From: Randall Hicks <r@rthicksconsult.com>
Sent: Thursday, January 24, 2013 3:29 PM
To: Leking, Geoffrey R, EMNRD
Cc: 'Richard Wright'; rickmassey11@aol.com; 'Dale Littlejohn'; 'Kristin Pope'; Warnell, Terry G.
Subject: Caza - Lennox 32 State 2H

30-025-40451

From: Dale Littlejohn <dale@rthicksconsult.com>
Sent: Monday, October 01, 2012 3:03 PM
To: Leking, Geoffrey R, EMNRD
Cc: Randall Hicks (r@rthicksconsult.com); VonGonten, Glenn, EMNRD; Gonzales, Elidio L, EMNRD; Jones, Brad A., EMNRD
Subject: Re: Distance to ground water at the Lennox 32 State No. 2H
Attachments: Lennon 32 #2H OFR 95 Maps.pdf

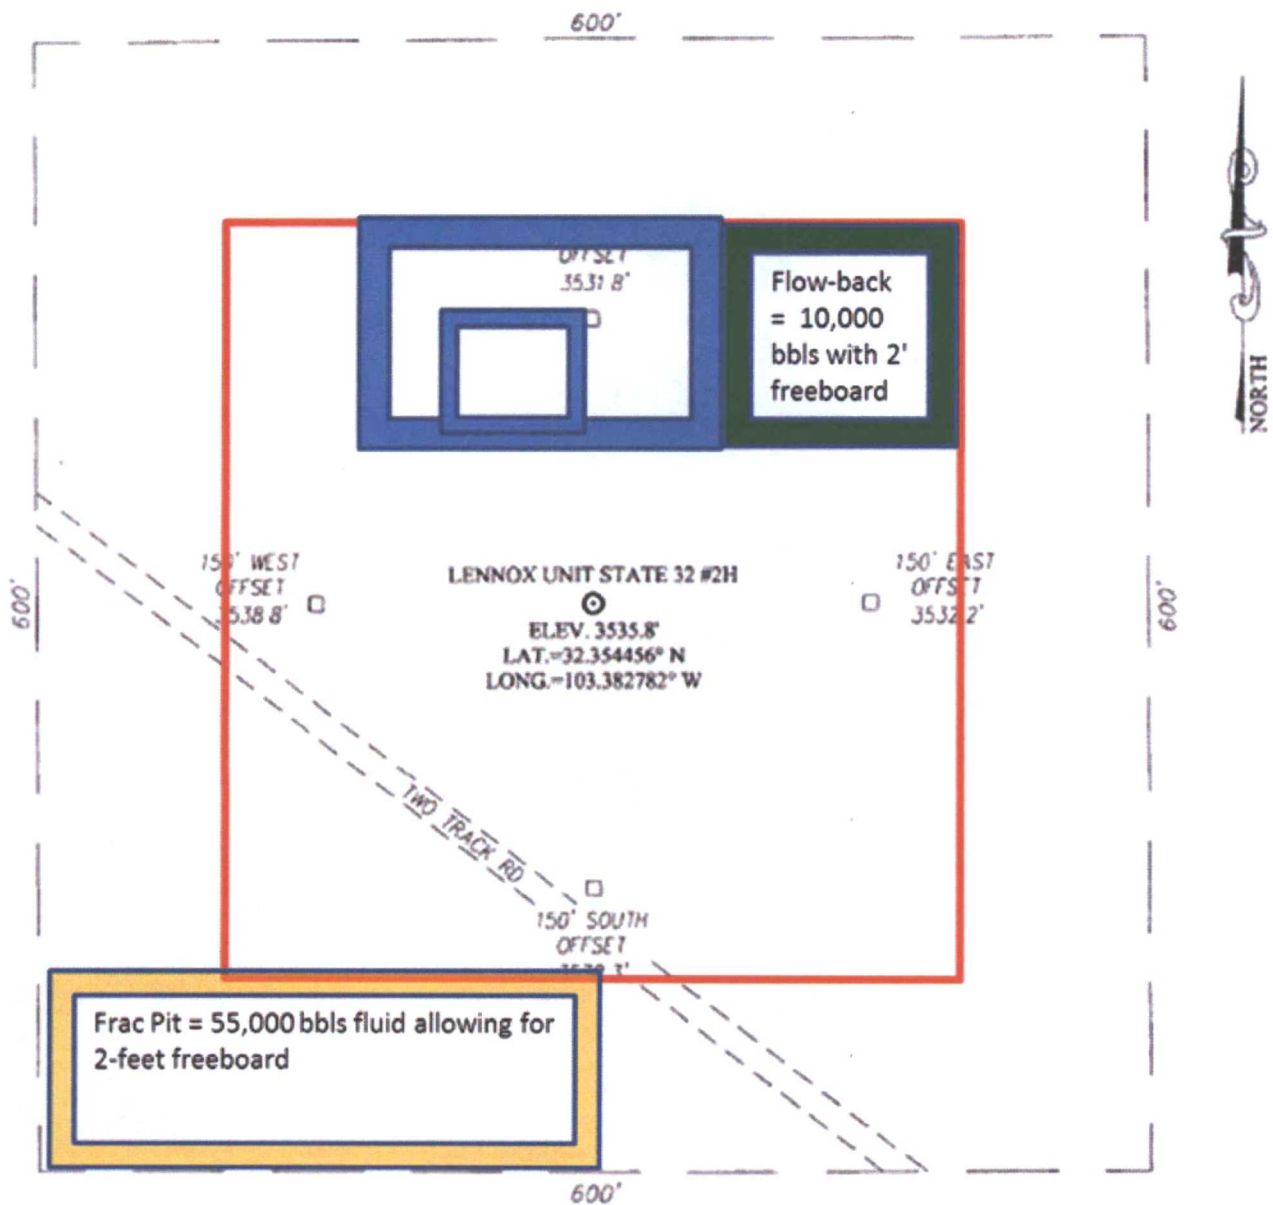
We constructed the pit according to the permit. The footprint and depth are about the same as we planned. There are two changes

1. The temporary pits are on the north side of the location, not the east side and
2. A frac pit to hole only fresh water is located within the State Lease as shown.

While we do not need a permit from OCD, SLO or the OSE for the frac pit, we thought it a good idea to notify everyone that it does exist. The OSE granted a permit for a water well, which will be located northeast of the flow-back cell of the temporary pit.

Figure 1: Open File Report No. 95 – Groundwater Elevation Map

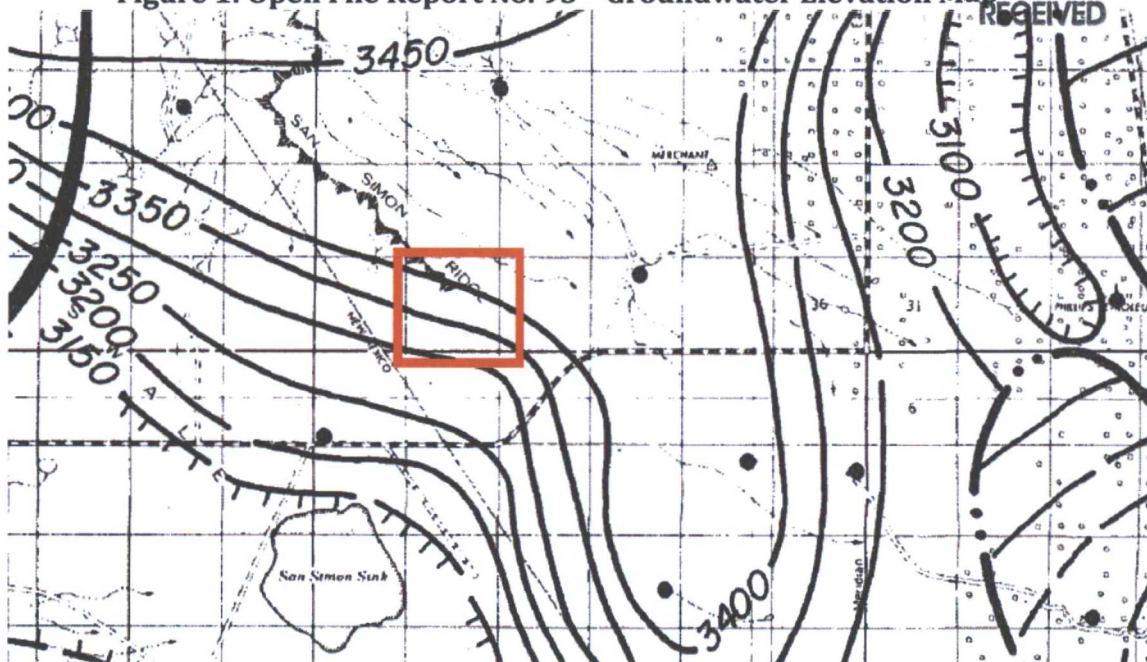
As an example of how depth to groundwater maps can be misleading, Figures 1 and 2 on the attached document are water level elevation and depth to groundwater maps of the area of the proposed pit that are in Open File Report OF-95 (see http://geoinfo.nmt.edu/Open-file_Reports/OFR014-99/76-99/95). Section 32 is outlined by the red box in Figures 1 and 2. Note that the depth to water map suggests a distance of less than 100 feet between ground surface and groundwater. However, the groundwater elevation map suggests that the elevation of groundwater is 3,400. The survey presented in the C-144 shows the surface elevation of the site is 3,535. Thus one map shows a groundwater depth of less than 100 feet while the same authors of OF-95 predict a depth to groundwater of about 135 feet using the potentiometric surface. Which map is correct? The depth to groundwater map obviously does not consider the local topography. The potentiometric surface map is a representation of the elevation of groundwater, which allows professionals to determine the depth to groundwater at a place of known surface elevation.
